## GENERAL APPLICATION

Location Address: 2200 MADISON STREET

**SUBJECT:** Site Plan review for a 12 unit residential development (Madison Apartments).

**SITE PLAN**  
SCALE: 1/8"=1'-0"  
ZONED DH-2 EXISTING VACANT RESIDENTIAL

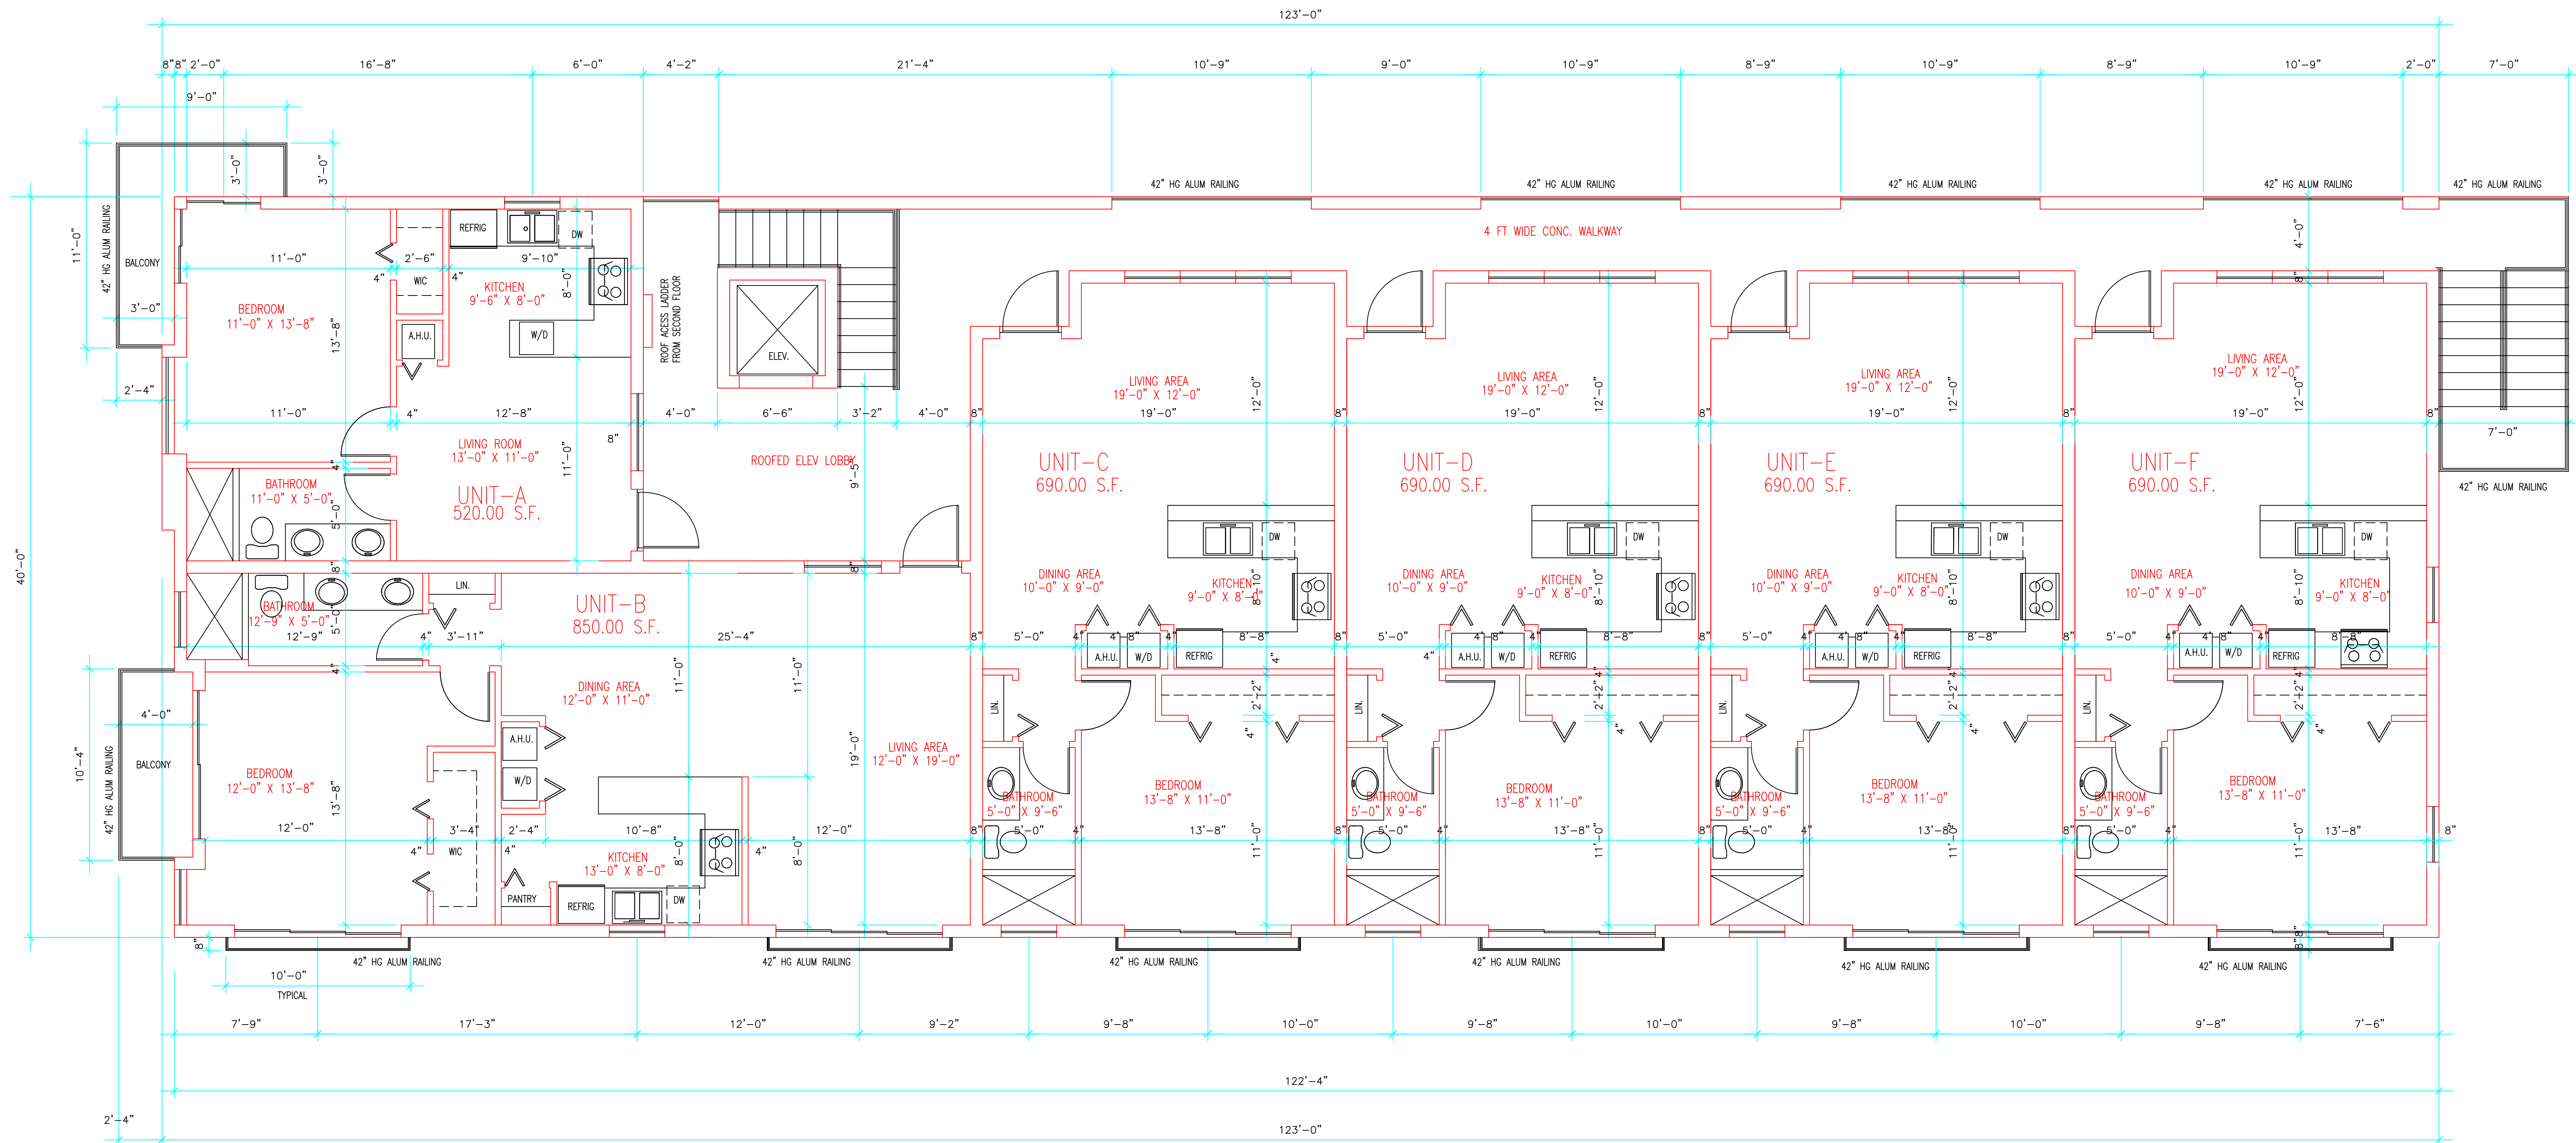
4. Revise the following on Site Plan:
  - a. Indicate all required setback dimensions.
  - b. Indicate location for recycling.
  - c. Drawing shall be fully dimensioned, including but not limited to, architectural projections and parking stalls.

- d. Include existing utility poles on site, including dimensions from the proposed building.
  - e. Include note on Site Plan indicating that all changes to the design will require planning review and may be subject to Board approval.

- f. Work with the City's Landscape Architect to ensure that all landscape requirements are met.
5. Revise the following on Site Data Table:
  - a. Current Land Use and Zoning designations not provided. Revise accordingly.

1. Sheet 1: The Dumpster enclosure does not have any details to review. How is recycling being accommodated?
2. Sheet 1: The A/C compressors are shown on the ground level where they can be vandalized. Consideration should be given to relocating them to the roof of the building.
3. Sheet 1: Is the elevator hydraulic? I don't see machine room.
4. Sheet 1. There is no room dedicated to janitorial supplies with a mop sink. How is the property to be maintained?
5. Sheet 2: Neither exit stair is in a fire rated enclosure.
6. No roof plan was included for review.
7. Parking appears to be inadequate for the number of units.

LEFT SIDE ELEVATION

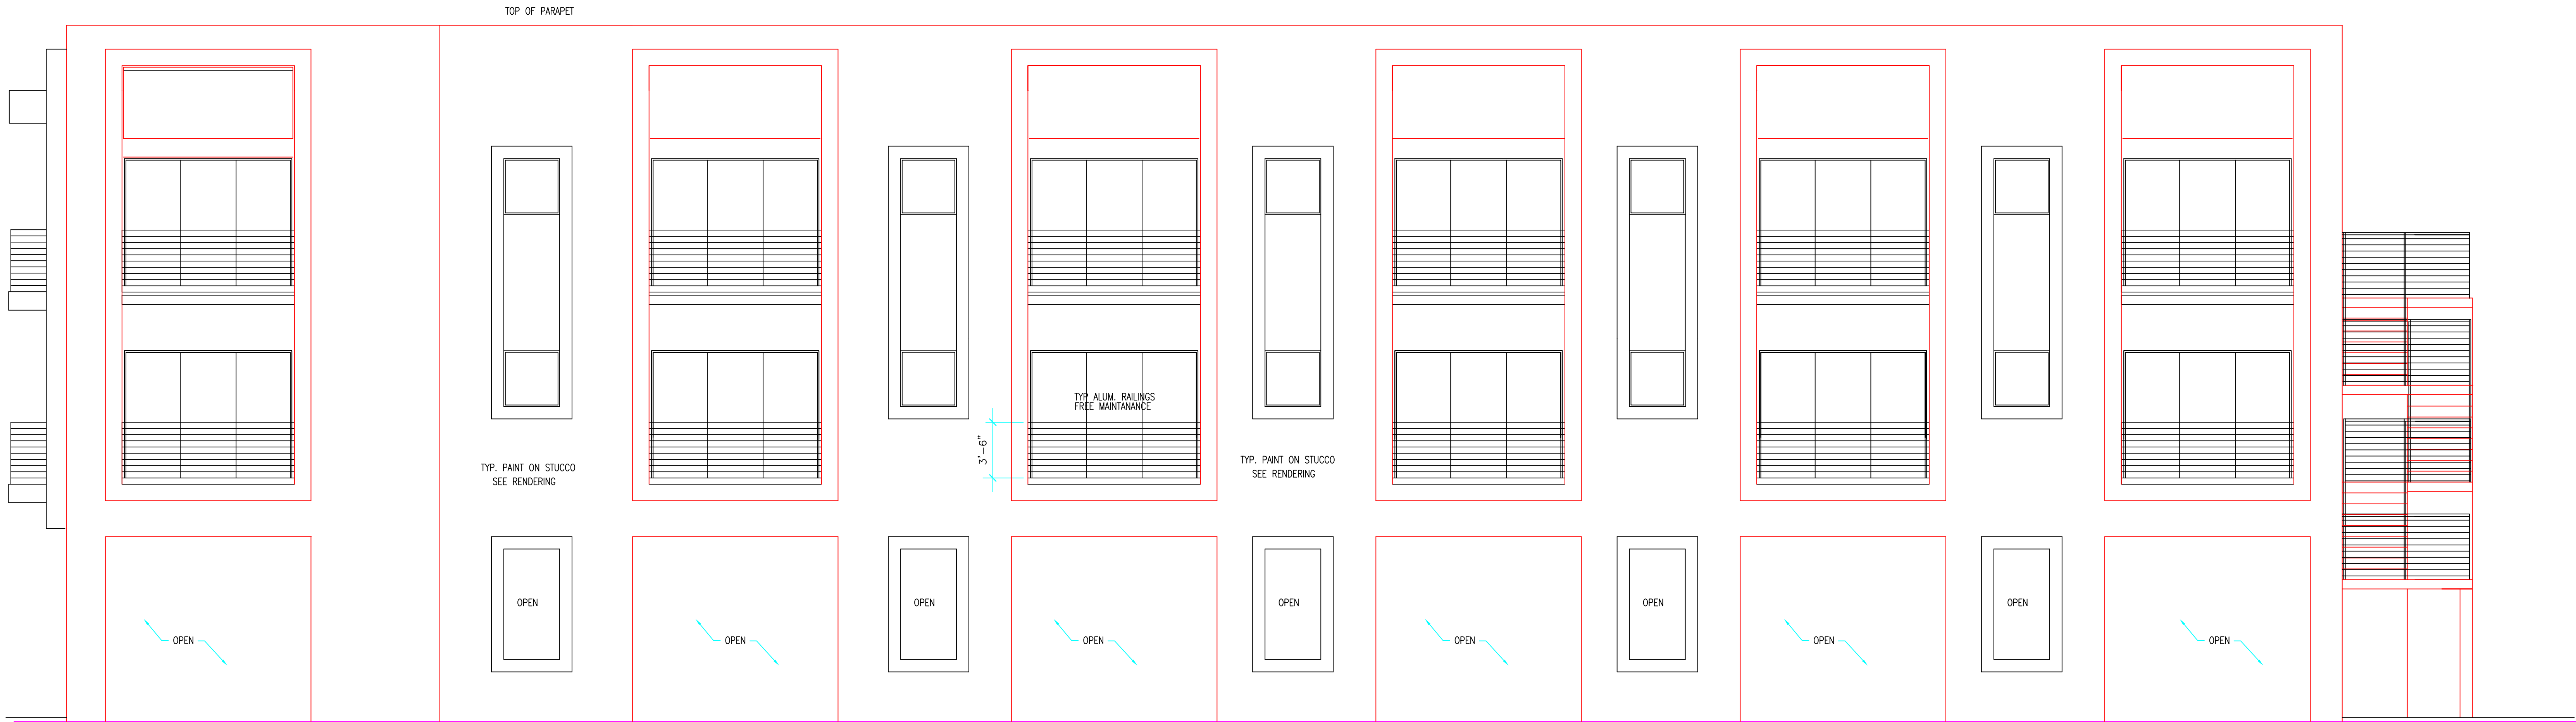
11. Consider providing accessible balconies for each unit.
12. Consider revising North (Front) Elevation:
  - a. Front elevation does not match rendering. Revise accordingly.

- b. Scoring to a texture and detail to large blank walls.
14. Consider revising South (Rear) Elevation:
  - a. Include additional window in bedroom in Unit-F to balance rear façade.

- b. Consider removing window in living room in Unit-F on third floor.
  - c. Scoring to a texture and detail to large blank walls.
